IMPORTANT SAFETY RECALL NOTICE

NHTSA RECALL NO. 13V-543 SCHOOL BUS
NHTSA RECALL NO. 13V-545 NON-SCHOOL BUS

Blue Bird Body Company has decided that a defect which relates to motor vehicle safety exists in certain 2014 model year Blue Bird All American and Vision model school and non-school buses manufactured from July 02, 2013 through October 03, 2013.

Front Suspension Rear Shackle Bolts

Bolt head with “ZY” code

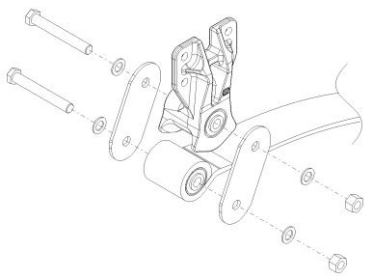
The front suspension rear shackle bolts may break as a result of hydrogen embrittlement which may have occurred during the bolt manufacturing process.

Inspect the front suspension rear shackle bolts for “ZY” code on the bolt head. Replace any rear shackle bolt that has the “ZY” code.

1. Park bus on a level surface, apply parking brake, turn off ignition, remove ignition key and chock rear wheels.
2. Underneath the bus, locate the front suspension, rear shackle bolts on the right (curb) side and left (drivers) side of the chassis.
3. Inspect the head of the bolt for “ZY” code. If there is no “ZY” code on any of the four bolts, no further action is required. Document the bolt head code for all four bolts on the enclosed R13WR Inspection Sheet.

5. Remove one bolt at a time. DO NOT REUSE, dispose of according to Federal, State, and Local regulations. Install new bolt, two new hardened flat washers, and new lock nut. Torque to 300 FT.LBS.
